Planning Comments 1:

1-B-21-SU
11/24/2020

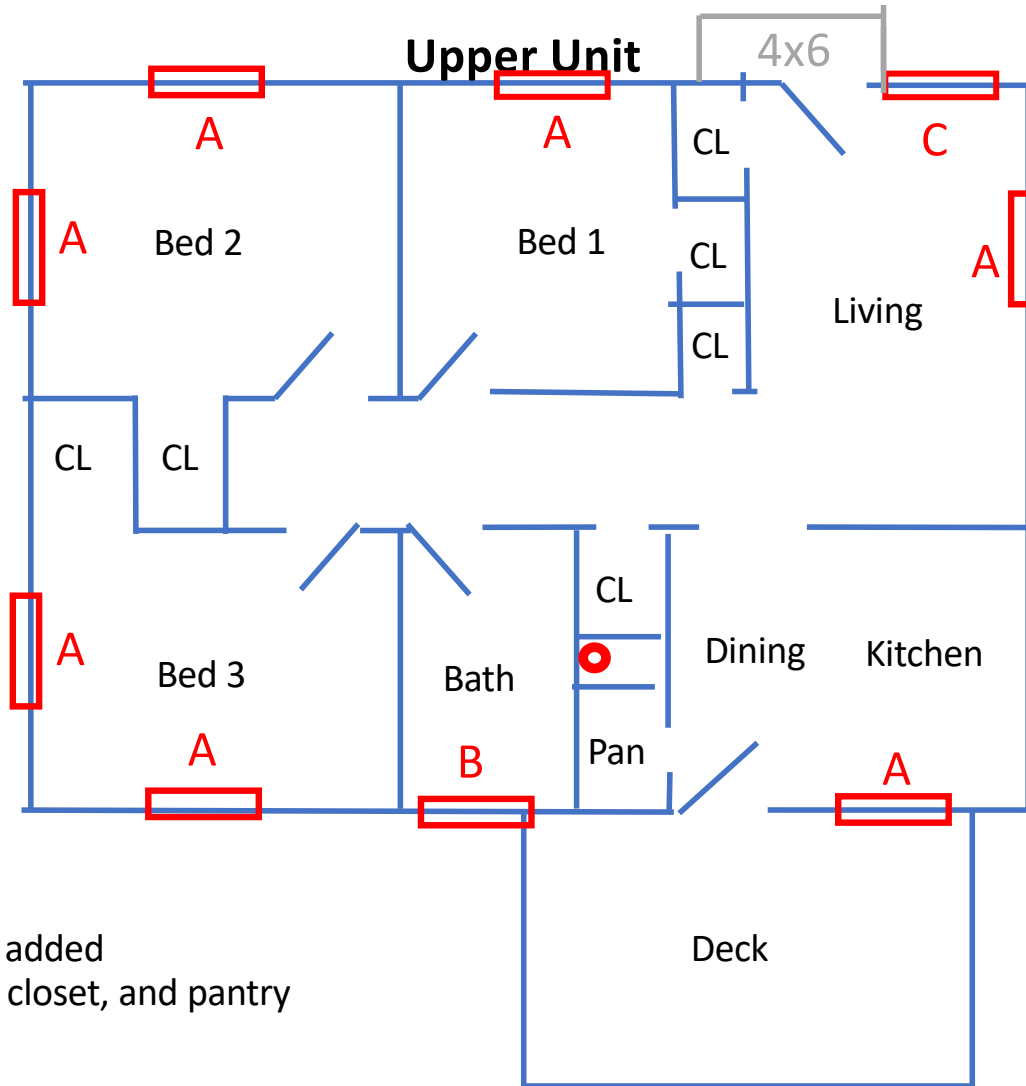
- A – 36" x 36" window
- B – 17" x 36" window
- C – 48" x 60" window
- D – 36" x 28" window
- – 3" fire collar

LVP flooring to be added
in kitchen, dining, closet, and pantry
area
